Access Compliance Report

Public Rights-of-Way

(Curb Ramps)

Intersection ID: 52630	Main Street: WEYMOUTH_LN	Cross Street: ALEXANDER_DOWD_DR	Location:	E
ADA ID: 7820406FE4A8	Ramp Type: Perp	Initial Pass/Fail: Fail	Overall Compliance: No	Severity Score: 12.5
Codes/Mitigation Info/Possible Solution		Field Measurements/Component Compliance

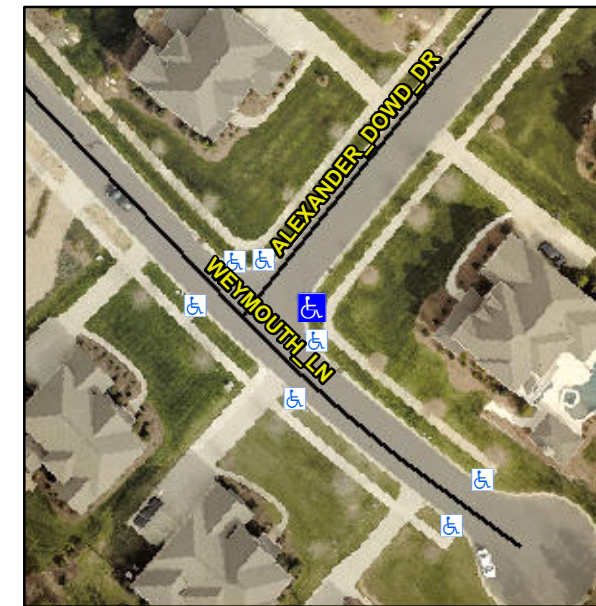
Not Found, R304.5.3

Compliance	Description	Data	Compliance	Description	Data
N/A	Ramp Length (in)	95.0	Yes	Ramp Slope (%)	5.5
Yes	Ramp Width (in)	58.0	No	Ramp XSlope (%)	6.6
N/A	Flare Type LT	N/A	N/A	Flare Type RT	N/A
N/A	Flare Slope LT (%)	N/A	N/A	Flare Slope RT (%)	N/A
N/A	Flare Traversable LT?	N/A	N/A	Flare Traversable RT?	N/A
N/A	Landing Length (in)	N/A	N/A	DWS Provided?	N/A
N/A	Landing Width (in)	N/A	N/A	DWS Contrast?	N/A
N/A	Landing Slope (%)	N/A	N/A	DWS Length (in)	N/A
N/A	Landing X Slope (%)	N/A	N/A	DWS Full Width?	N/A
N/A	Landing Curb? (Y/N)	N/A	N/A	DWS Offset (in)	N/A
N/A	Shared Landing?	N/A			
N/A	Gutter Ponding?	N/A	N/A	Gutter Slope (%)	N/A
N/A	Gutter Lip Ht (in)	N/A	N/A	Gutter X Slope (%)	N/A
N/A	Painted X Walk1?	No	N/A	Painted X Walk2?	N/A
	X Walk 1 Direction	To NW		X Walk 2 Direction	N/A
N/A	X Walk 1 Width (in)	N/A	N/A	X Walk 2 Width (in)	N/A
	X Walk 1 Slope (%)	4.1		X Walk 2 Slope (%)	N/A
	X Walk 1 X Slope (%)	4.5		X Walk 2 X Slope (%)	N/A

Remove & Replace Entire Ramp.
